**RE: ADDITIONAL GROUND WATER MONITORING REQUIRMENTS FOR SPILL
SITE 61 (AOC 1001)
HOLLOMAN AIR FORCE BASE
EPA ID# NM6572124422
HWB-HAFB-04-005**

The New Mexico Environment Department (NMED) has performed additional review of the AOC 1001 site investigation history and the *Interim Final, Focused Feasibility Study, Spill Site 61* dated September 2004. Based on this review the NMED has additional concerns and requirements regarding this site. NMED believes the additional requirements will prevent future delays for implementation of the anticipated corrective measures study (CMS).

NMEDI interpretation of Groundwater Data From Phase II RI Report

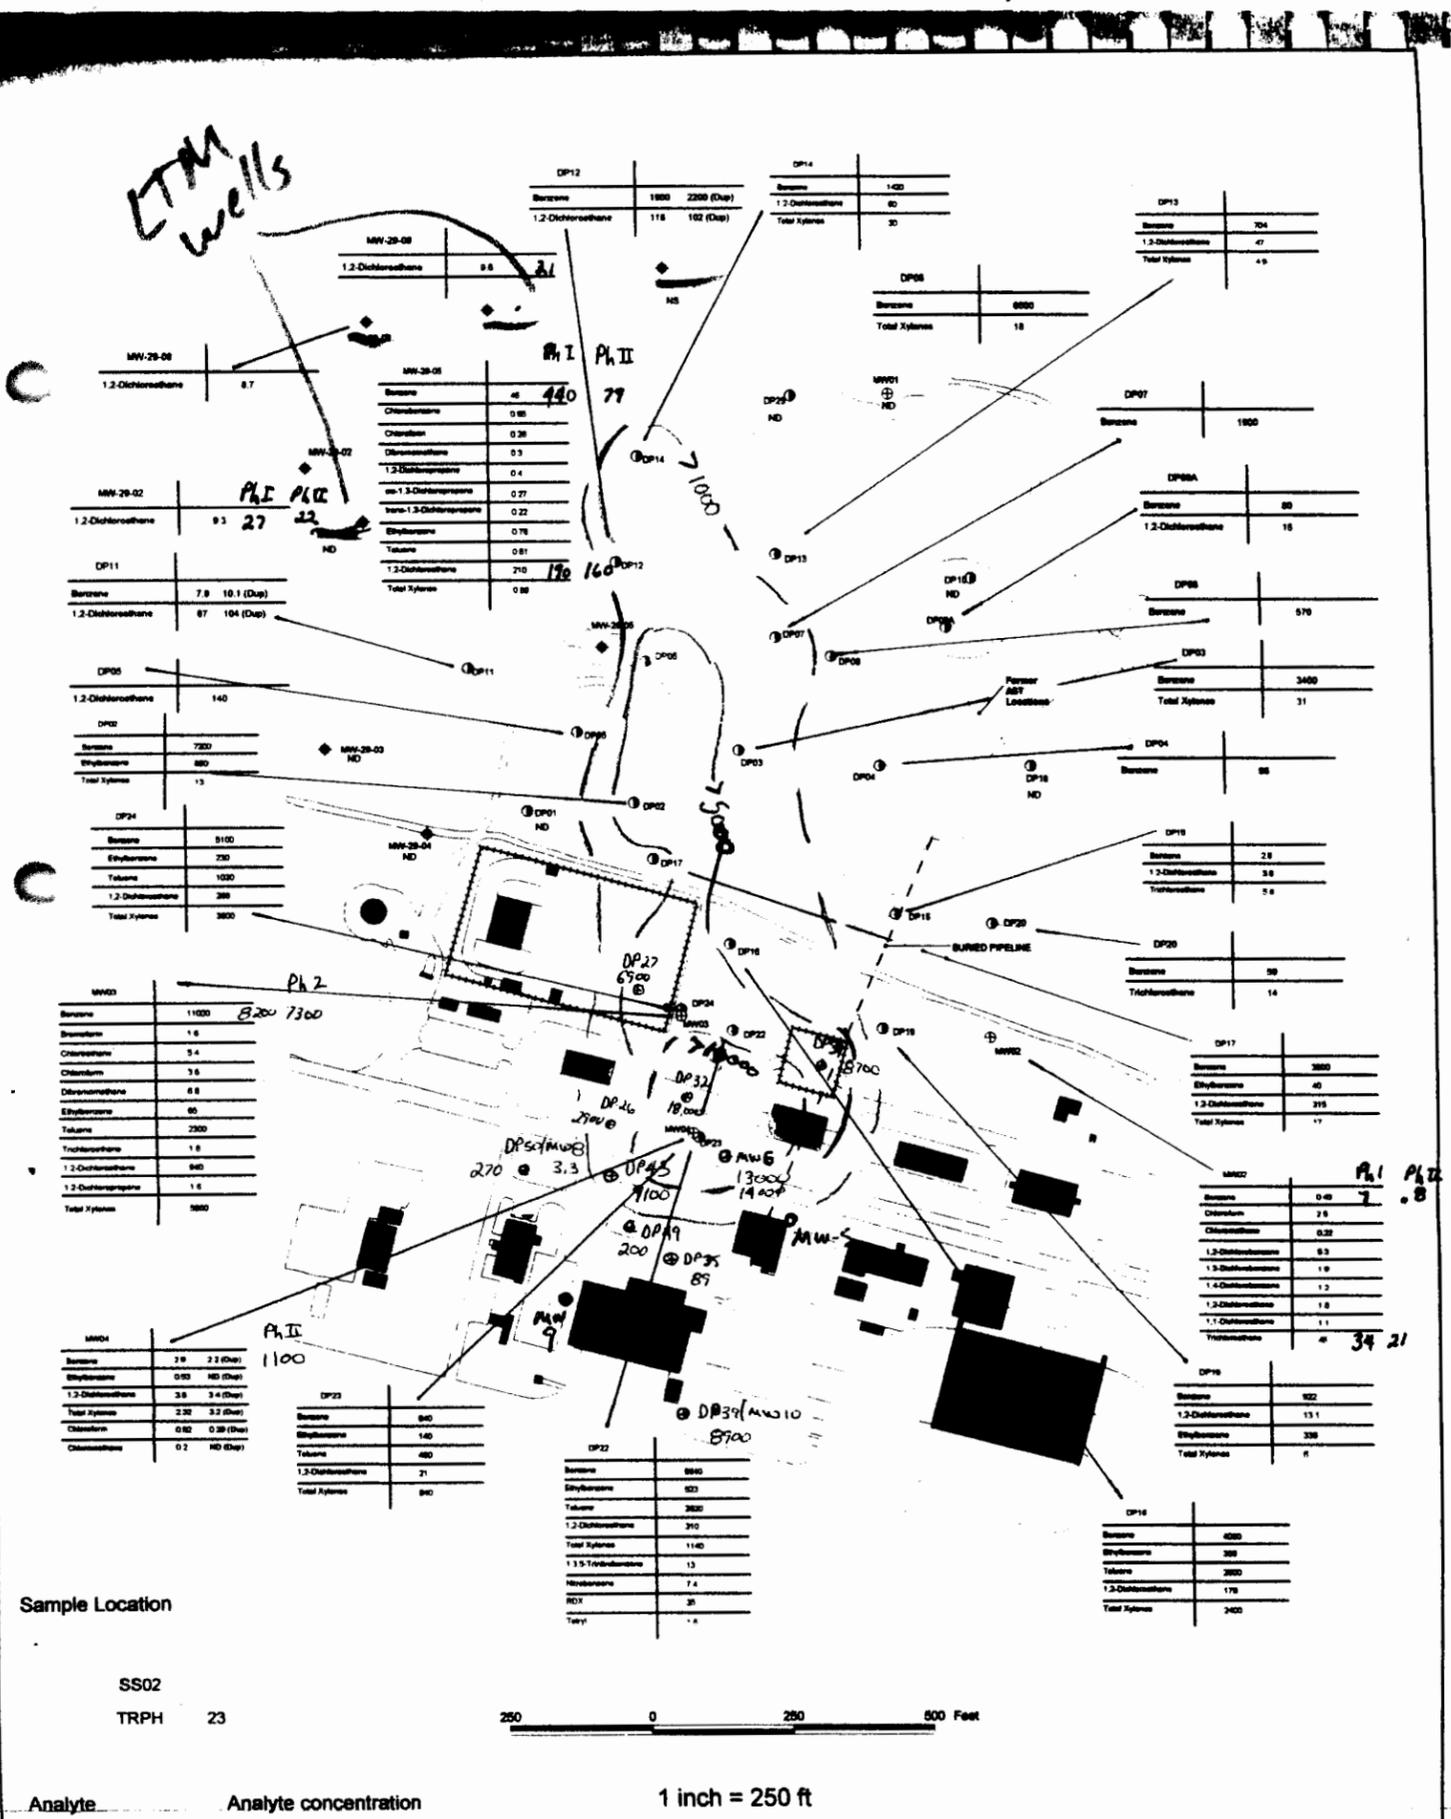
1. The contaminant plume appears to be migrating in a northerly direction and not with the ground water flow direction. The potentiometric surface maps for May 2000 (Fig 3-3, Final Phase II RI Report) and June 2004 (Interim Final Focused Feasibility Report) indicates a ground water flow direction that is slightly north of west. A detailed plot of the ground water contaminant plume based on data from Figures 5-3, 5-4, and 5-5 of the Phase II RI report, indicates the contaminant plume is migrating in a north-northwest direction.

2. The RI report also concluded that the 1,2 DCA was attributed to a separate solvent plume. This may not be the case. 1,2 DCA is also a fuel additive referred to as ethylene dichloride (EDC). A plot of the benzene and 1,2 DCA plumes appear to indicate one source for both of these plumes.

3. The previous investigations have also identified a TCE contamination in the eastern portion of the site. Ground water samples from MW-02 and DPT locations DP15, DP29, DP47, DP36, and DP56 along the eastern portion of the SS-61 site investigation had detections for TCE. This is in the upgradient portion of the site, based on ground water flow and may represent a distal end of a TCE contaminant plume. If TCE migration is similar to the benzene/EDC plume, then a TCE source may exist south or southeast of MW-02 (possibly from Building 1088 or 1080).

1. NMED will require that the natural attenuation feasibility study associated with the approved work plan and the CMS report be compiled and submitted separately due to the significant differences that these reports entail.
2. Additional investigation of the TCE plume to the east and southeast of MW-02 must be performed.
3. A ground water sampling program must be established. Ground water samples must be collected from a sufficient number of wells throughout the plume on at least a semi-annual basis. NMED suggest that initially the following wells and analysis be included for sampling:
 - i) MW-09 or 10, MW-05, MW-08, MW-06, MW-03, MW-02, MW-29-04, MW-29-05, MW-29-02 and MW-29-08
 - ii) All wells should be analyzed for the following constituents:
